Solicitation No.: B240003BAG

Solicitation Name: Sunniland / Nine Mile Run Drainage Improvement Project

Subject: Addendum Number 1

AERIAL - EXISTING CONDITIONS									
SUNNILAND / NINE MILE RUN DRAINAGE IMPROVEMENT PROJECT									
LEE COUNTY, FLORIDA									
DATE	PROJECT	DRAWING	DESIGN	DRAWN	CHECKED	SCALE	SHEET		
5/14/2019	8234	_AER	KWK	SDJ	KWK	1"=300'	03

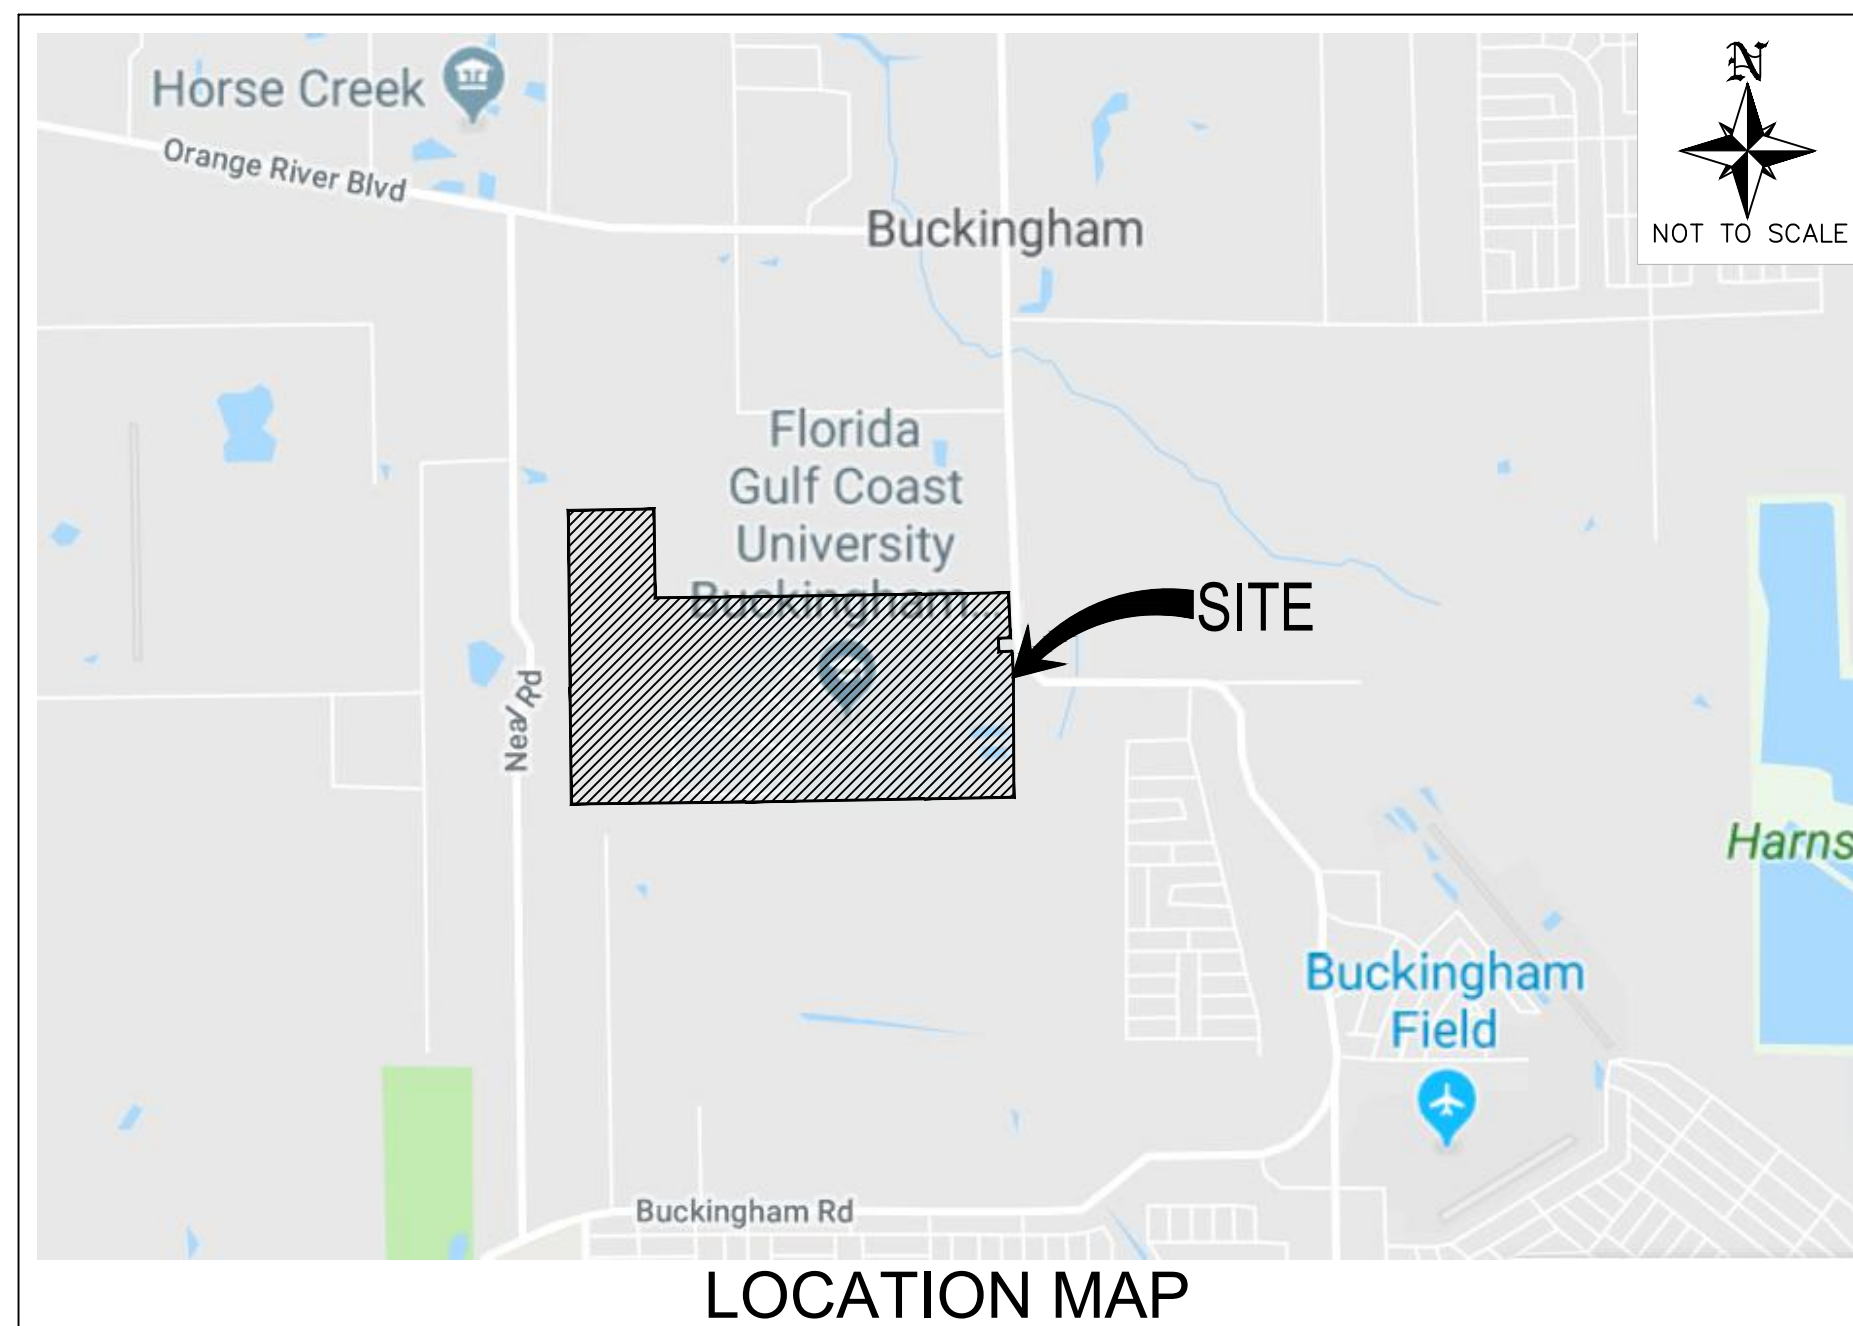
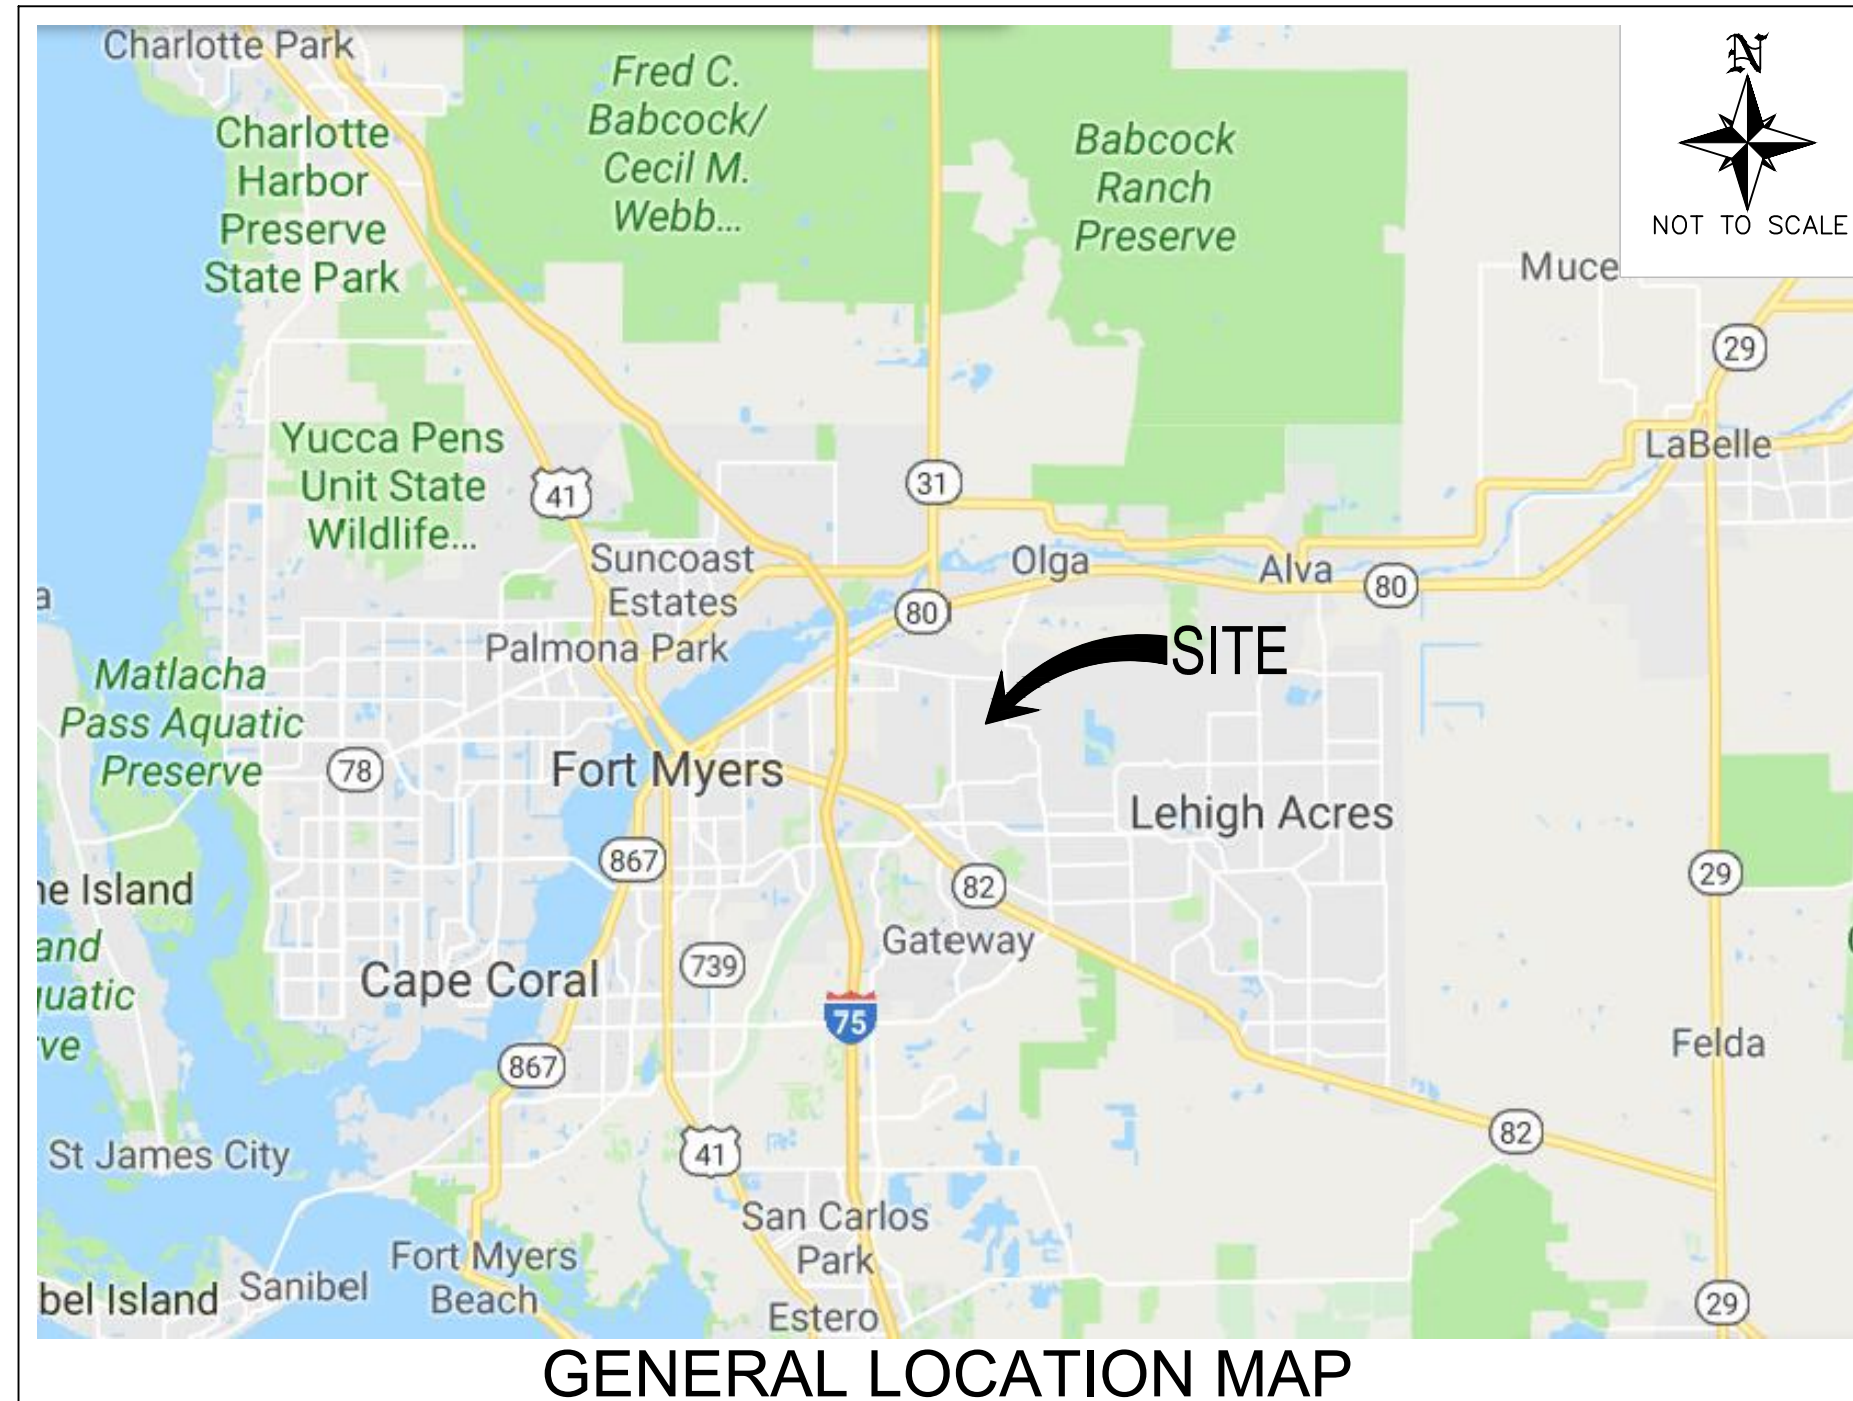
Answer	30-inch MES has been added to the Bid Form.
17.	Drawing Sheet 3 depicts a note that reads, "All off-site hydraulic drainage connections must be maintained". Can the engineer explain the anticipated process necessary to accomplish this task?

Answer	Do not block off-site flows from entering the canal.
18.	A quick measurement of the work area enclosed by the by the silt fence depicts a much larger area of clearing and grubbing than the 4 acres listed on the bid form. Can the engineer please confirm the clearing and grubbing measurement? However, if the 4 acres is correct, can the engineer explain what measurements (areas) are to be included?

MASTER ENGINEERING PLAN						
SUNNILAND / NINE MILE RUN DRAINAGE IMPROVEMENT PROJECT						
LEE COUNTY, FLORIDA						
DATE	PROJECT	DRAWING	DESIGN	DRAWN	CHECKED	SCALE
5/14/2019	8234	_AER	KWK	SDJ	KWK	AS NOTED
						SHEET 05

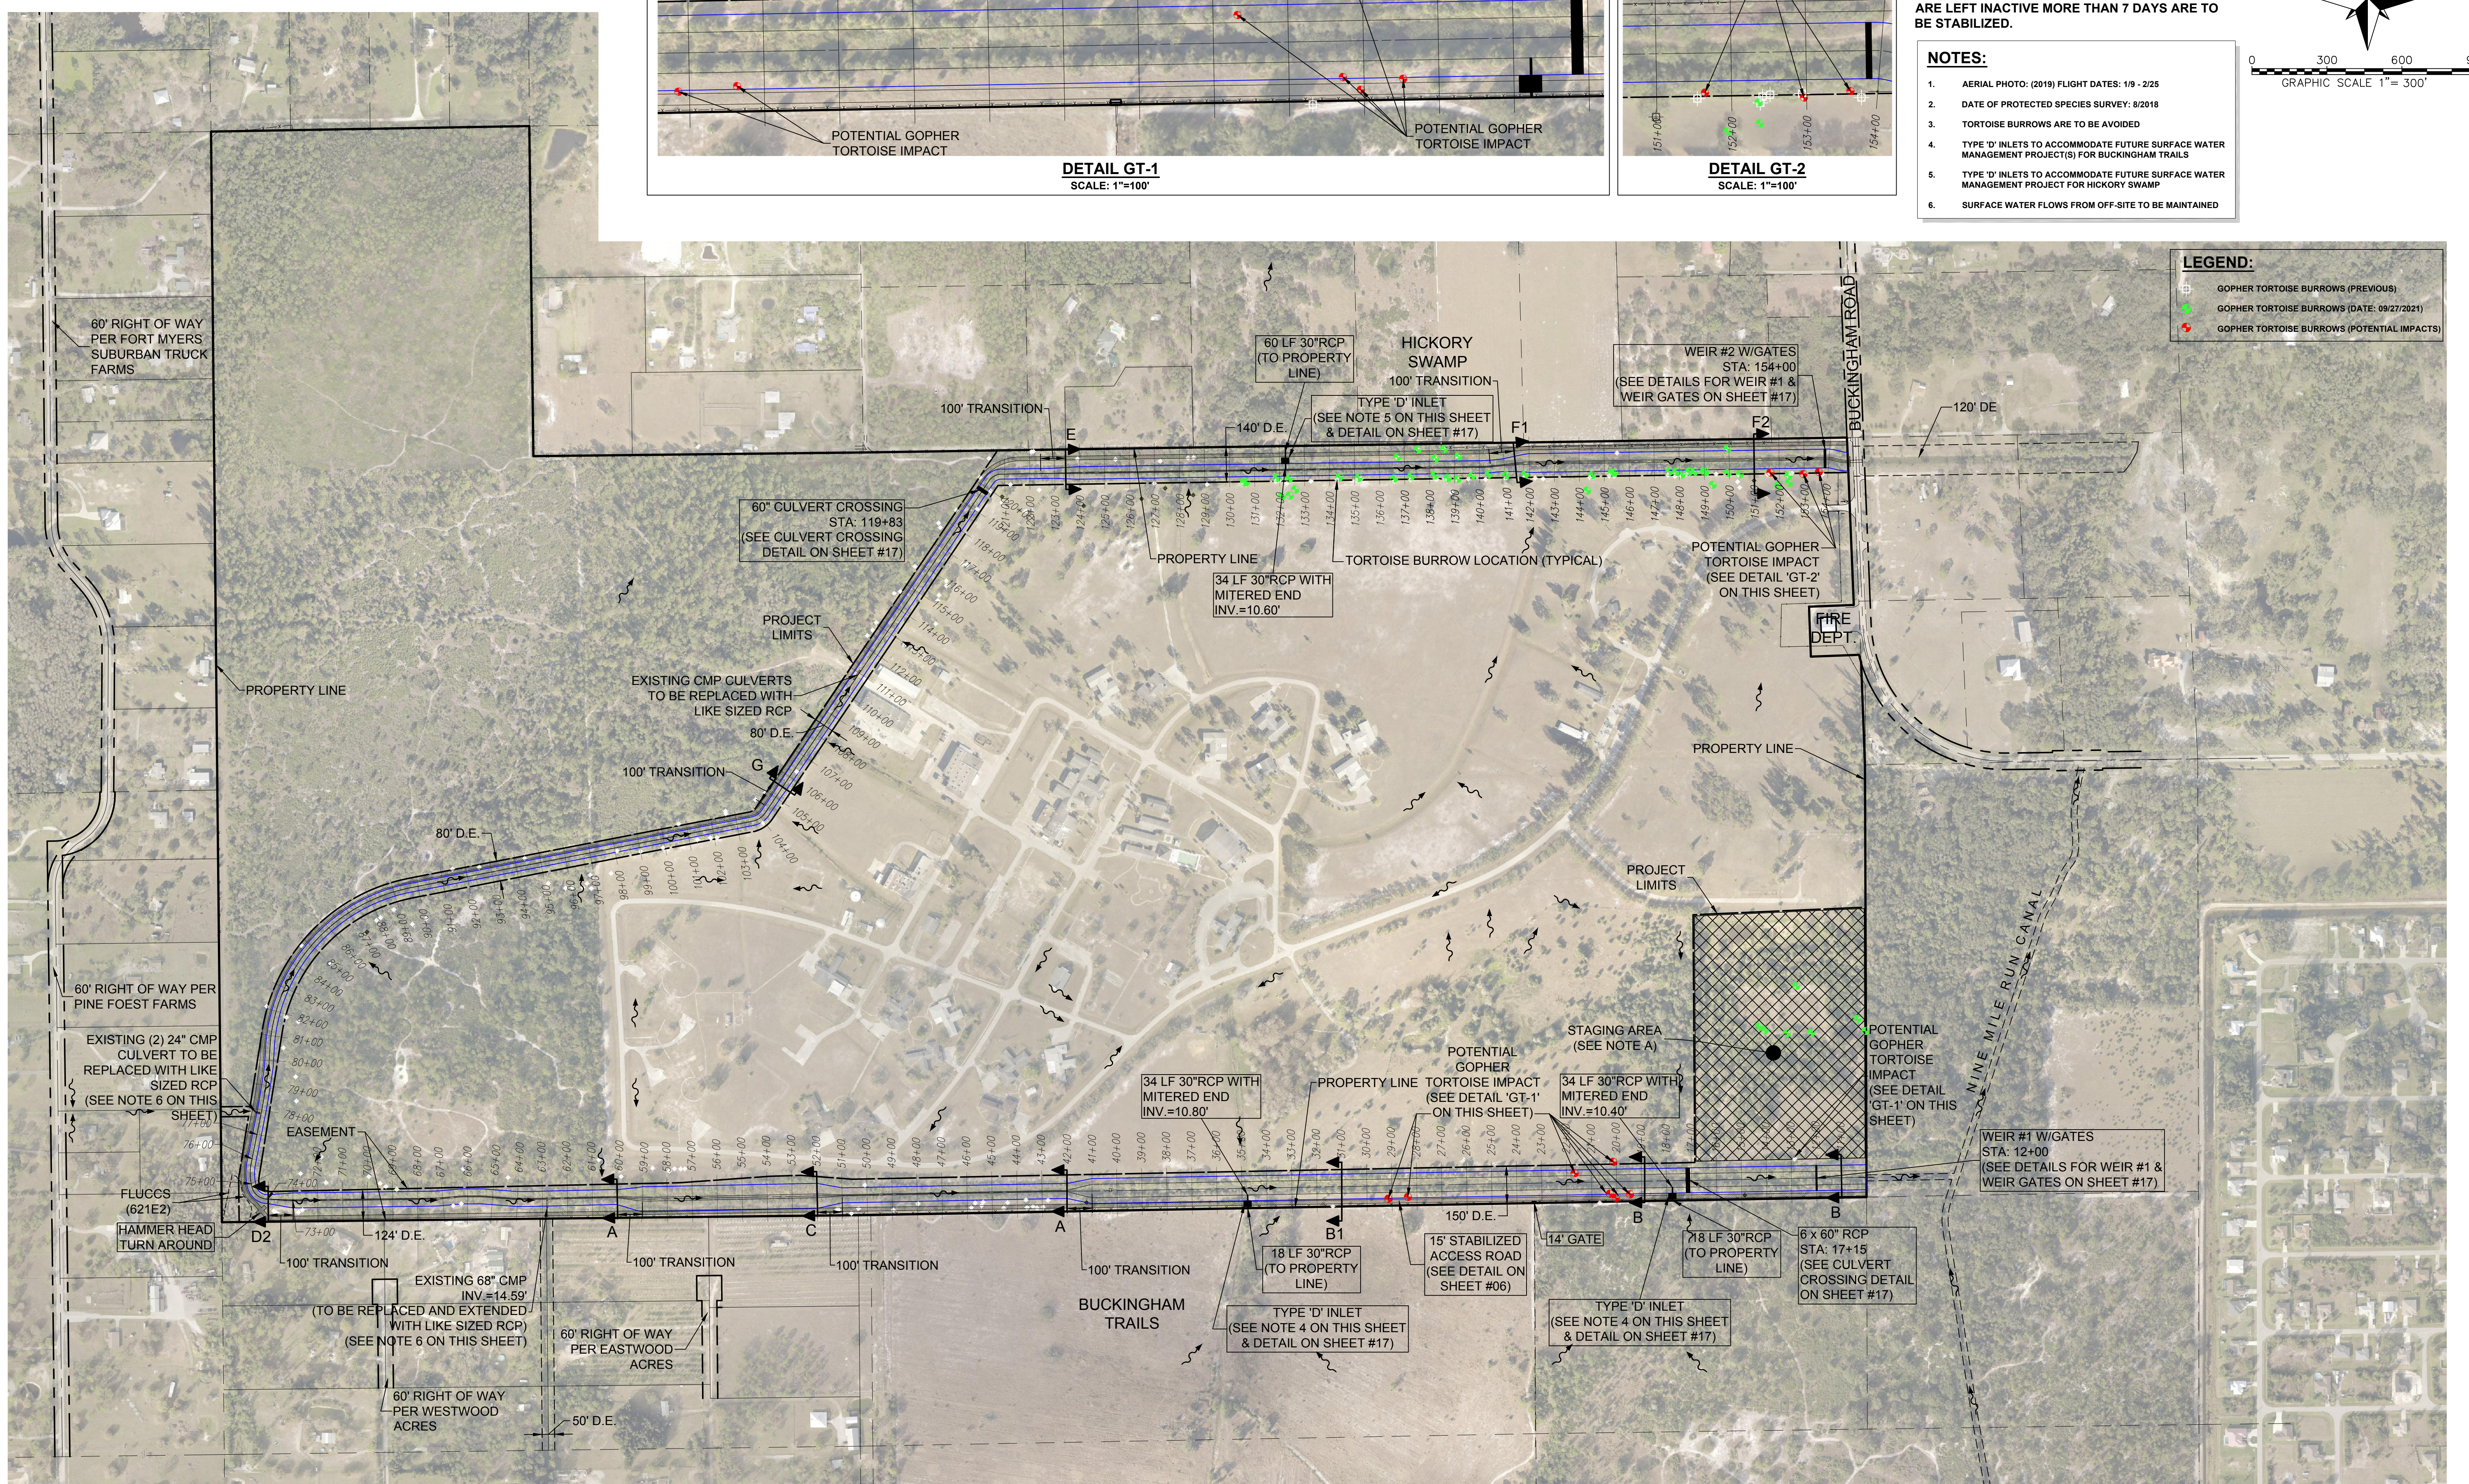
Answer	Please refer to the geotechnical report included in this addendum.
7.	Referencing sheet 05 & 06, Section D1 (sta.19 +00) depicts a canal section bottom at elev. + 14.00 with a TOB measurement width of 35'. Sheet 07 cross section shown for sta. 19 +00 represents a totally different profile view of the ditch section. Question which one is correct?

Answer	See Section B for STA 19+00.
8.	Referencing sheet 05 & 06. Section D2 (sta.31 + 00) depicts a canal section bottom at elev. + 14.00 with a TOB measurement width of 35'. Sheet 08 cross section 31 + 00 represents a totally different profile view of the ditch section. Question which one is correct?

Answer	Sheets 17A and 17B are correct. Ignore section on sheet 17.
16.	Drawing Sheet 5 depicts (3) thirty-inch RCP mitered end sections. However, the bid form does not list any. Can a new 30" MES bid item be included on a revised bid form?
